Product Change Notification (PCN)

PCN #: 6E-2022   *DATE: 10th August 2022*

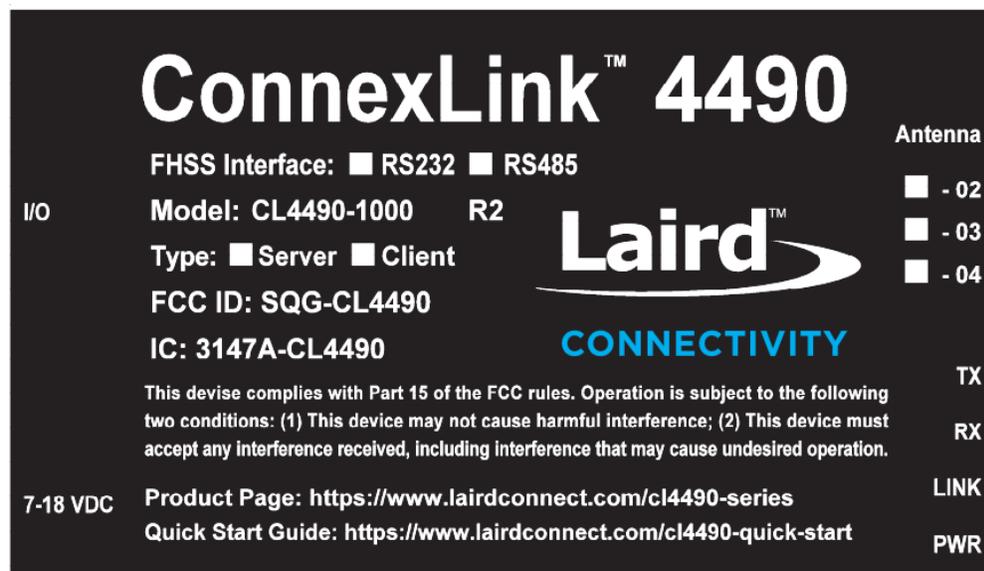
- Changed Qorvo RF power amplifier (RF6886)
- Changed RF filters (LPF ceramic and BPF SAW) but with similar specifications.
- 14.7456MHz crystal changed and body size reduction, but with similar specification.
- Passive component body size reduction
- and therefore, PCB layout changed

The Qorvo RF power amplifier (RF2173) used on old pre-revision 2.0 hardware is now EOL (End of Life).
Improve manufacturing processes and supply chain capability for required components.

- Regulatory Test and resubmission with new FCC and ISED IDs
- Updated labelling
- RF performance maintained from prior hardware revisions
- No software changes.
- No form, fit or function changes.
